ATTACHMENT TO LICENSE AMENDMENT

TURKEY POINT UNITS 3 AND 4
Docket Nos. 50-250 and 50-251

Marked-up Technical Specification Pages

FIGURE 6.2-1
BFF-SITE ORGANIZATION FOR FACILITY
MANAGEMENT AND TECHNICAL SUPPORT

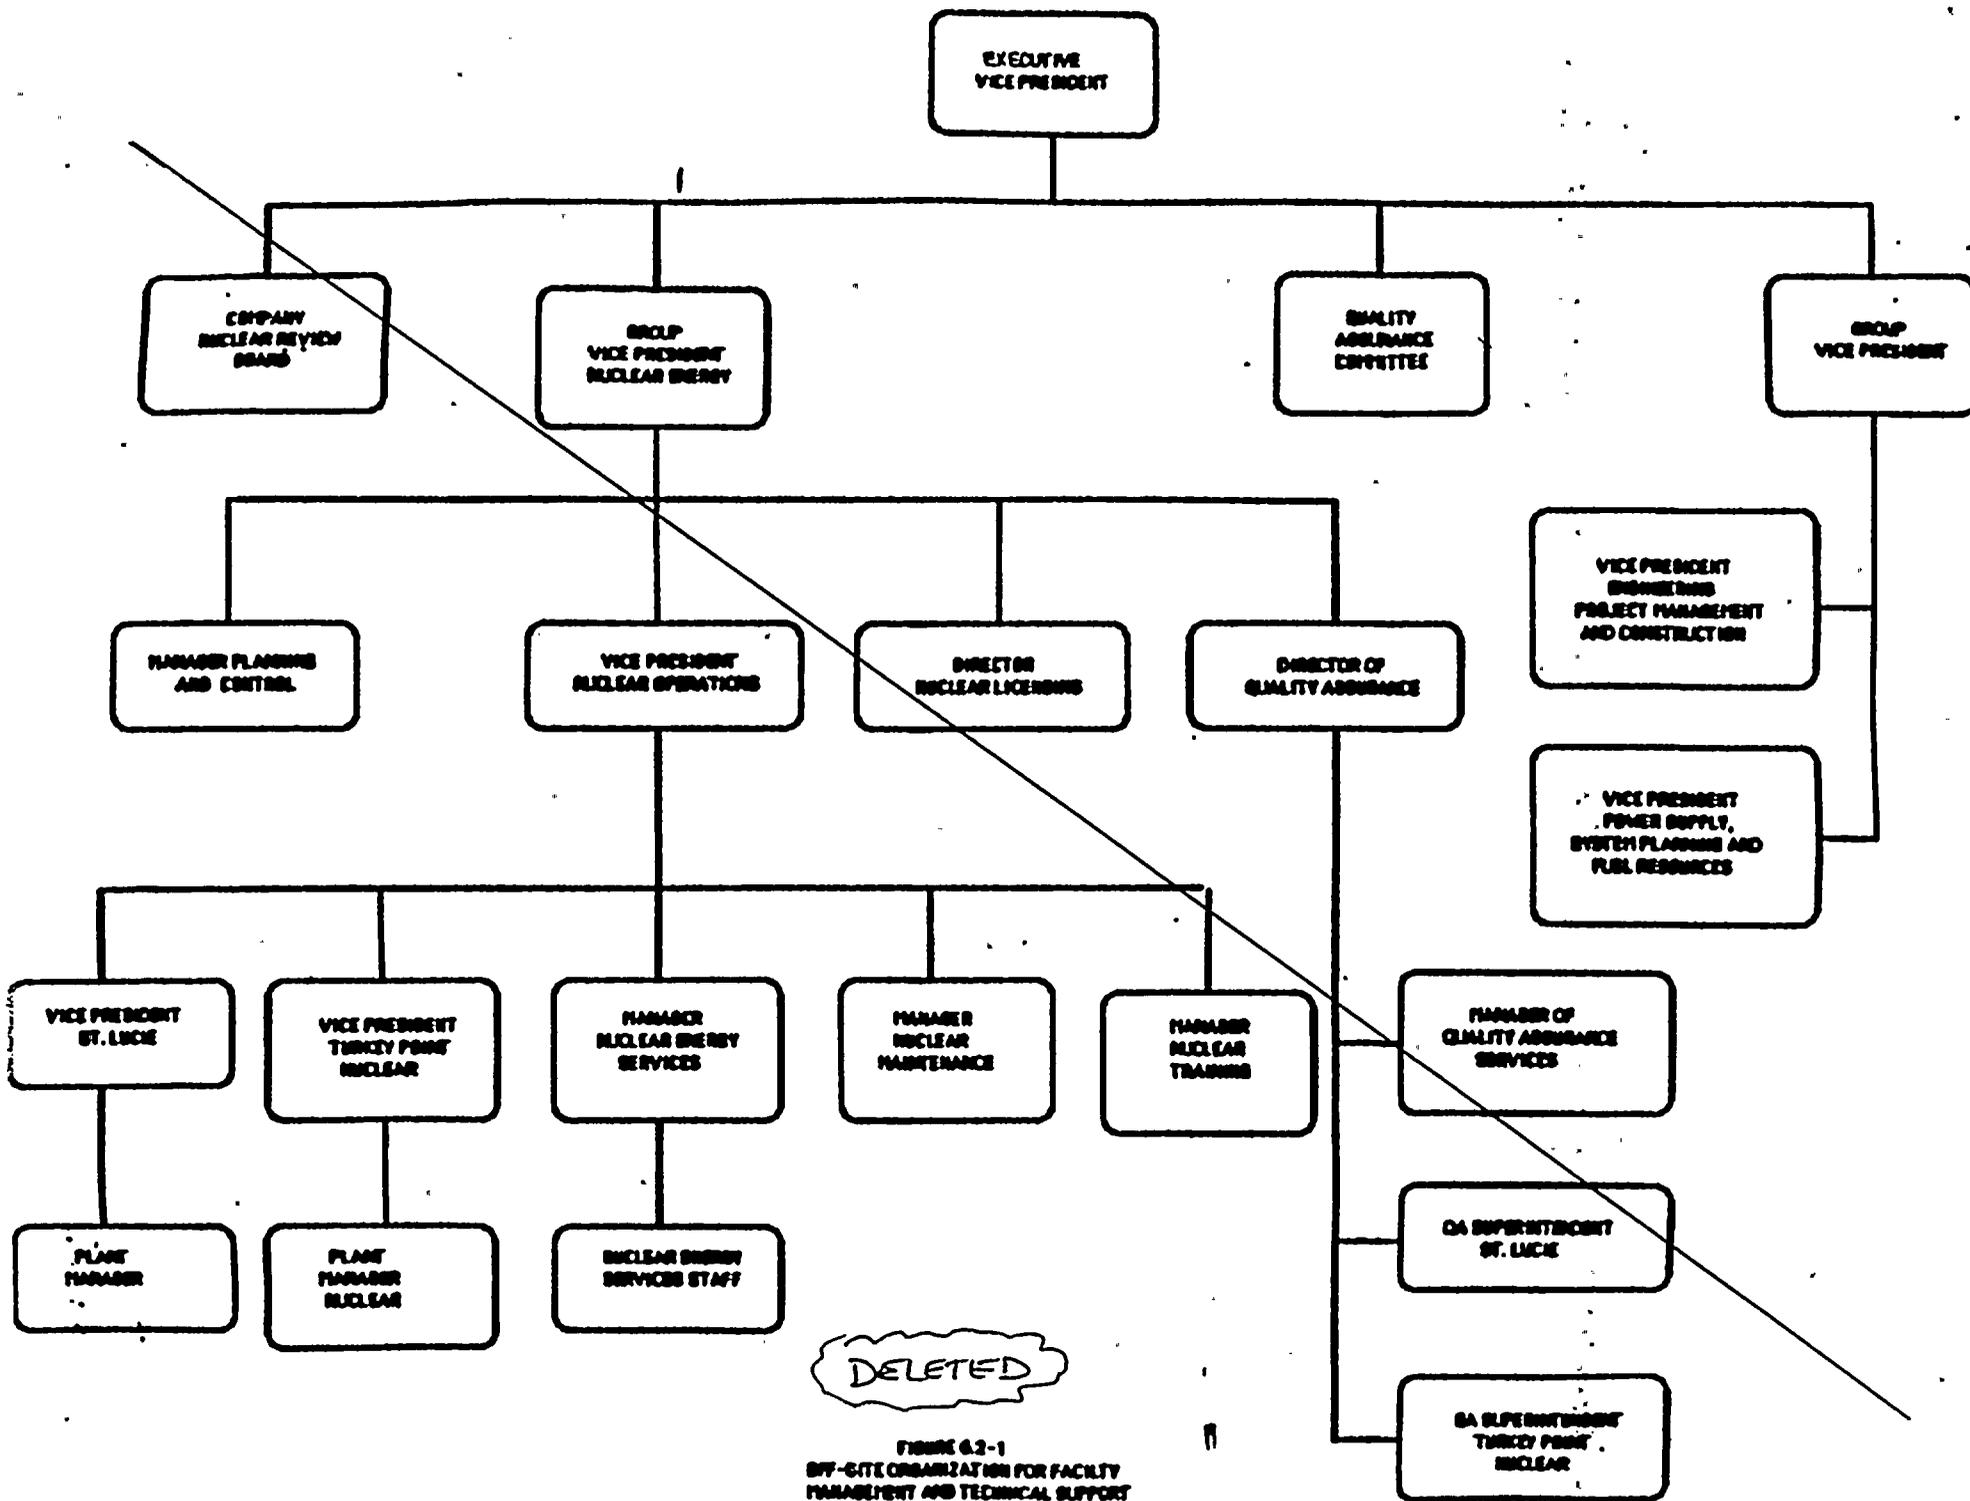
3.2-3	K (z) vs Core Height
3.2-3a	Deleted
3.2-4	Maximum Allowable Local KW/FT
4.12-1	Sampling Locations
5.1-1	FPL Turkey Point Site Area Map
6.2-1	Offsite Organization for Facility Management and Technical Support DELETED

~~The offsite organization for facility management and technical support shall be shown on Figure 6.2-1.~~

6.2.1 ~~OFFSITE~~ ONSITE AND OFFSITE ORGANIZATION.

An onsite and an offsite organization shall be established for ^{Facility} operation and corporate management. The onsite and offsite organization shall include the positions for activities affecting the safety of the nuclear power plant.

- a. Lines of authority, responsibility and communication shall be established and defined from the highest management levels through intermediate levels to and including all operating organization positions. Those relationships shall be documented and updated; as appropriate, in the form of organizational charts. These organizational charts will be documented in the ^{and updated in accordance with 10 CFR 50.54(b)(3)} ~~Topical Quality Assurance Report~~

PLANT ORGANIZATION CHART
FIGURE 6.2-2

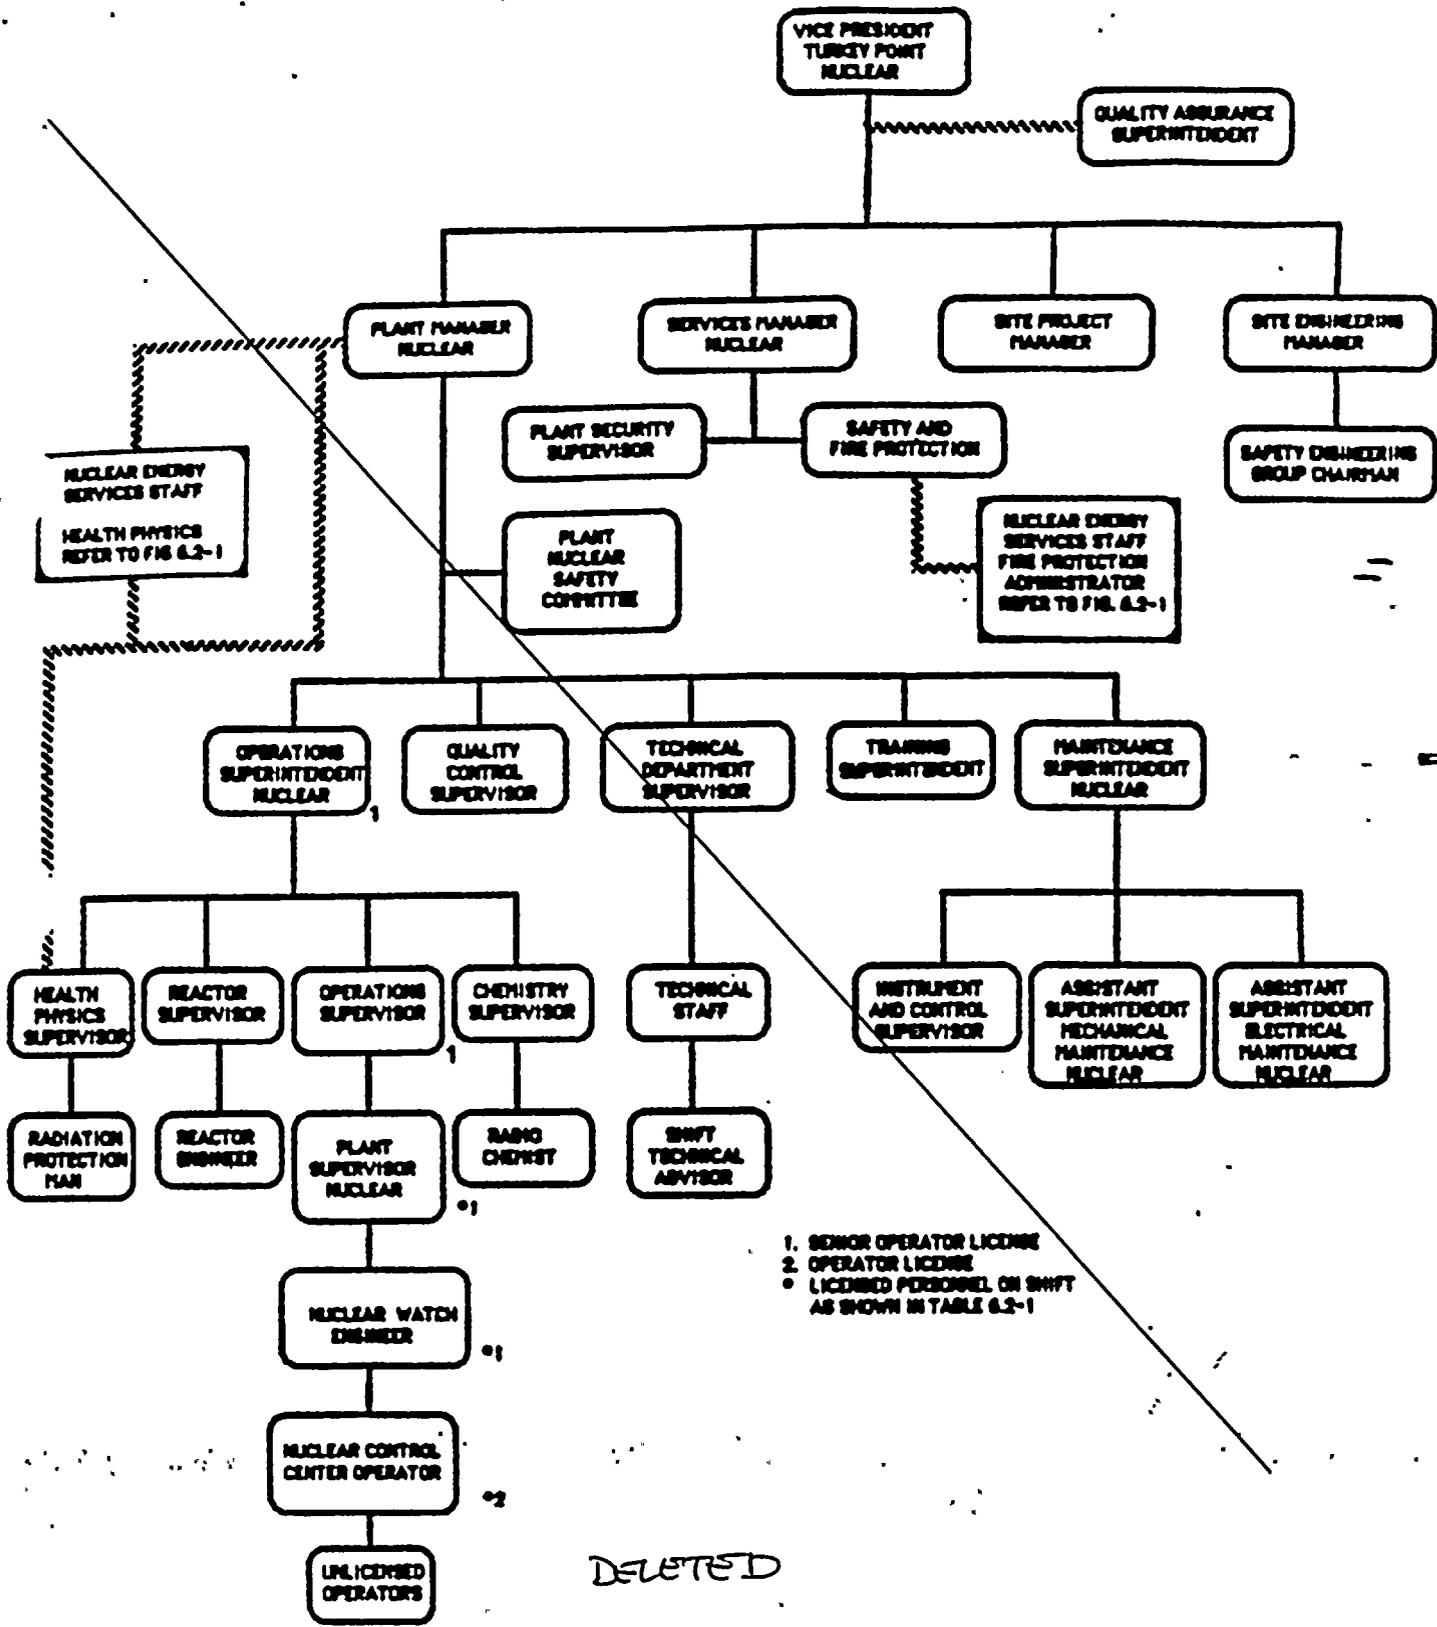
6.2-2	Plant Organization Chart DELETED
B3.1-1	Effect of Fluence and Copper Content on Shift of RT _{NDT} for Reactor Vessel Steels Exposed to 550 F Temperature
B3.1-2	Fast Neutron Fluence (E > 1MEV) as a function of Effective Full Power Years
B3.2-1	Target Band on Indicated Flux Difference as a Function of Operating Power Level
B3.2-2	Permissible Operating Band on Indicated Flux Difference as a Function of Burnup (Typical)

The Facility organization shall be ~~as shown on Figure 6.2-2~~ and:

DELETED

subject to the following
